## DEVELOPMENT APPLICATION ASSESSMENT REPORT

<b>Application Number:</b>	DA2022/0959
----------------------------	-------------

<b>Responsible Officer:</b>	Kye Miles
<b>Land to be developed (Address):</b>	Lot 4 DP 628329, 5 Cadow Street FRENCHS FOREST NSW 2086
<b>Proposed Development:</b>	Alterations and additions to a dwelling house
<b>Zoning:</b>	Warringah LEP2011 - Land zoned R2 Low Density Residential
<b>Development Permissible:</b>	Yes
<b>Existing Use Rights:</b>	No
<b>Consent Authority:</b>	Northern Beaches Council
<b>Land and Environment Court Action:</b>	No
<b>Owner:</b>	Christopher David Newell Claire Nicole Newell
<b>Applicant:</b>	Christopher David Newell

Figure 1. First floor rear setback non-compliance.

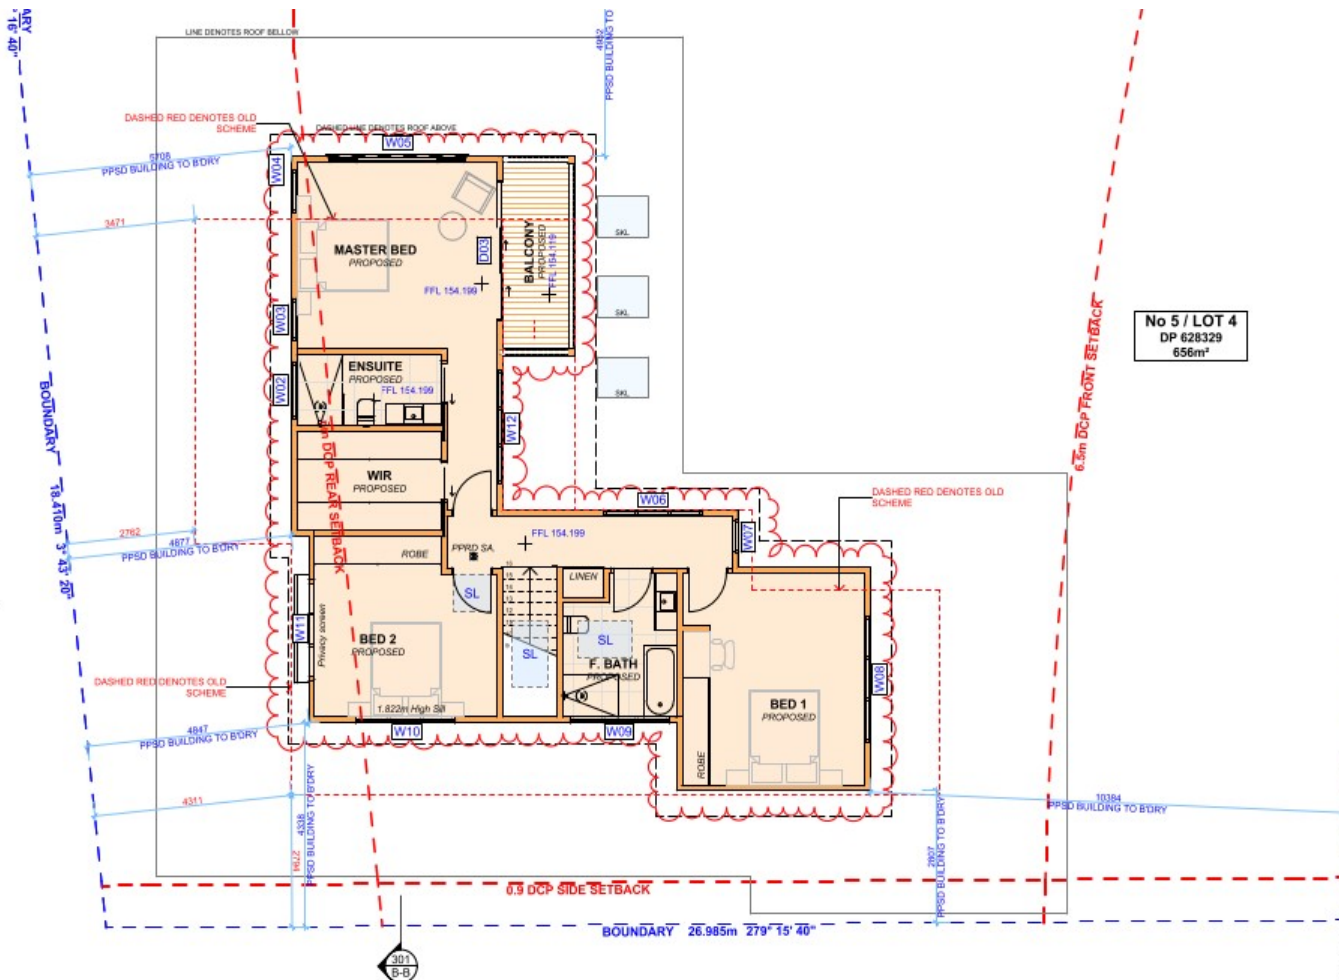
The proposed first floor is set back at a minimum of 4.8 meters from the rear boundary. WDCP requires a minimum rear setback of 6.0 meters.

The existing rear setback is primarily occupied by the ground floor of the dwelling and the rear terrace. Notwithstanding, the proposal maintains open yard space within the northern and

eastern setbacks. In addition, amended plans have been provided, which include limiting the first-floor encroachment within the rear setback, accounting for 7.3% (9.2m<sup>2</sup>) of the total area. Overall, the works will create an acceptable sense of openness in the rear yard.

This matter has been discussed in further detail under Part D8 Privacy of this report. In summary, the amended proposal provides an acceptable rear setback with consideration of the site constraints, while preserving reasonable privacy between buildings. The proposed first floor rear windows as to be amended by way of recommended condition will prevent casual overlooking into No. 42 Dundilla Road's private open space. Overall, the proposal has been appropriately sited to preserve privacy for the occupants of the development and occupants of the adjoining site.

The proposed first floor represents a minor encroachment within the total rear setback and will therefore retain consistency with the pattern of adjoining dwellings, which are also found on varied rear setbacks.
